Product Information Notice

Models: All Greenstar ZWB / ZBR Wall Hung Boilers

Subject: LP orifice O-ring replacement

Figure 3

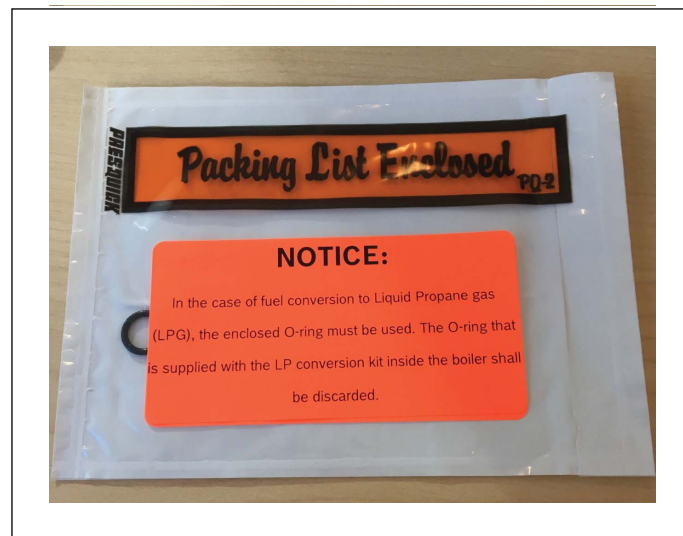
A limited amount of Greenstar boilers were produced with LP kits containing an incorrect O-ring (figure 1). This O-ring will not allow the LP orifice to fit into the gas pipe during an LP conversion as it is too large. For proper conversion with the orifice, the o-ring must be replaced.

A notice with spare O-ring (figure 3) has been included with existing inventory as of 11.16.17. Any additional replacements can be obtained free of charge by contacting customer service.
